Submission to SSD-61000021 at 146 Arthur Street, North Sydney

Stockland Corporation Limited (**Stockland**) submits this response to the State Significant Development Application (**SSDA**) for build-to-rent housing that is currently on Public Exhibition at 146 Arthur Street, North Sydney (SSD-61000021). Whilst Stockland supports the transformation of North Sydney with new commercial and residential developments to create a vibrant place, we object to this proposal and urge the Department of Planning, Housing and Infrastructure (**DPHI**) not to support the scheme in its current form. Our objections, as outlined throughout this letter, relate to the following matters:

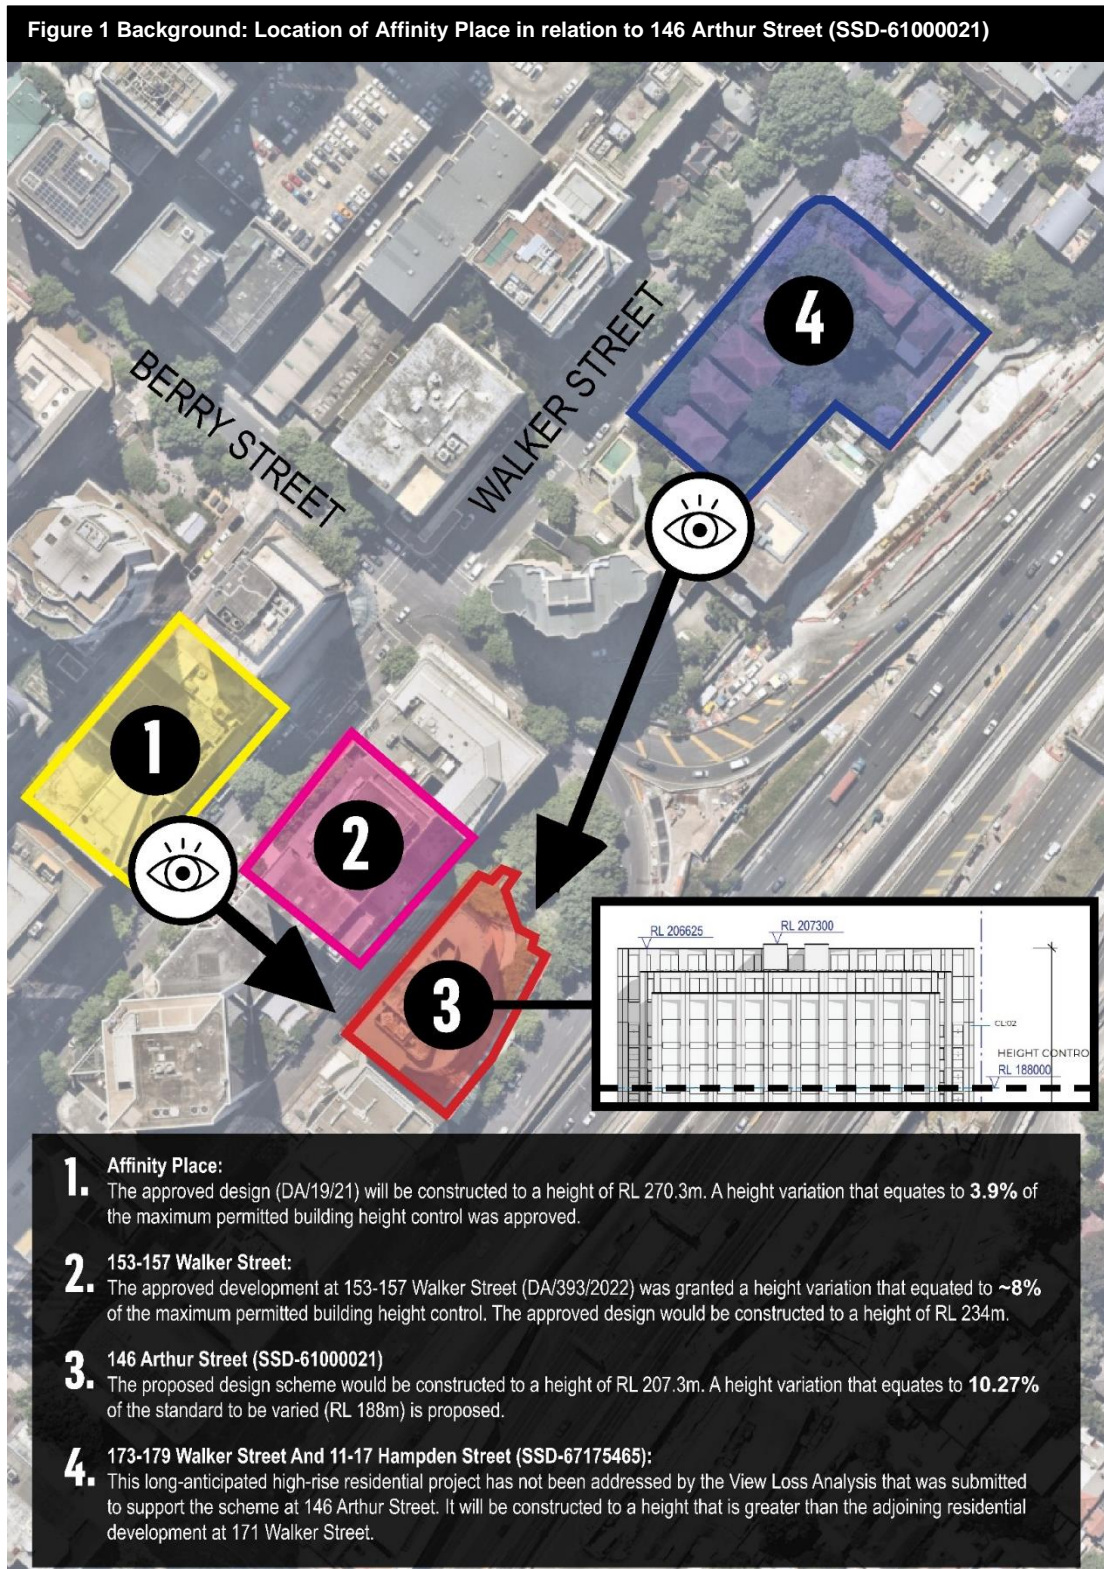
The proposed height variation for the scheme at 146 Arthur Street (10.27% of the permitted building height) is greater than the approved height variation for Affinity Place (3.9%). We note Council's Supplementary Assessment Report for D/19/21 (Affinity Place), dated 18 May 2022, classified the height variation for Affinity Place as 'minor'.

The substantial nature of the proposed height variation at 146 Arthur Street is discordant with the extent of approved height variations for high-rise development in the local area. In addition to Affinity Place (3.9%), the approved development at 153-157 Walker Street (DA/393/2022) was granted a height variation that equated to ~8% of the maximum permitted building height control (refer to Error! Reference source not found. overleaf).
